Access Compliance Report

Public Rights-of-Way

Intersection ID: 42943	Main Street: LONG_PAW_LN	Cross Street: SONOMA_VALLEY_DR	Location:	N
ADA ID: 4D5D686F81AA	Ramp Type: PerpDiag	Initial Pass/Fail: Fail	Overall Compliance: No	Severity Score: 8.75
Codes/Mitigation Info/Possible Solution		Field Measurements/Component Compliance

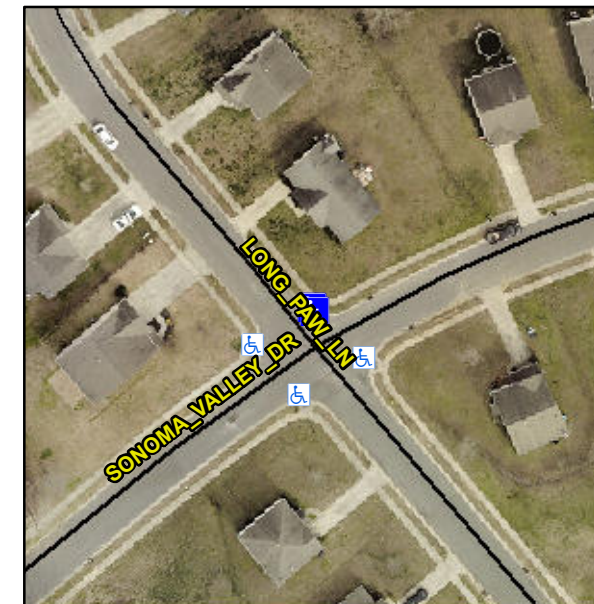
Not Found, R304.5.1

Compliance	Description	Data	Compliance	Description	Data
N/A	Ramp Length (in)	49.5	Yes	Ramp Slope (%)	5.0
No	Ramp Width (in)	46.5	Yes	Ramp XSlope (%)	1.3
N/A	Flare Type LT	N/A	N/A	Flare Type RT	N/A
N/A	Flare Slope LT (%)	N/A	N/A	Flare Slope RT (%)	N/A
N/A	Flare Traversable LT?	N/A	N/A	Flare Traversable RT?	N/A
N/A	Landing Length (in)	N/A	N/A	DWS Provided?	N/A
N/A	Landing Width (in)	N/A	N/A	DWS Contrast?	N/A
N/A	Landing Slope (%)	N/A	N/A	DWS Length (in)	N/A
N/A	Landing X Slope (%)	N/A	N/A	DWS Full Width?	N/A
N/A	Landing Curb? (Y/N)	N/A	N/A	DWS Offset (in)	N/A
N/A	Shared Landing?	N/A			
N/A	Gutter Ponding?	N/A	N/A	Gutter Slope (%)	N/A
N/A	Gutter Lip Ht (in)	N/A	N/A	Gutter X Slope (%)	N/A
N/A	Painted X Walk1?	No	N/A	Painted X Walk2?	No
	X Walk 1 Direction	To SW		X Walk 2 Direction	To SE
N/A	X Walk 1 Width (in)	N/A	N/A	X Walk 2 Width (in)	N/A
	X Walk 1 Slope (%)	3.1		X Walk 2 Slope (%)	6.6
	X Walk 1 X Slope (%)	3.1		X Walk 2 X Slope (%)	2.1

Remove & Replace Curb Ramp With Two New Directional Ramps or Equivalent.
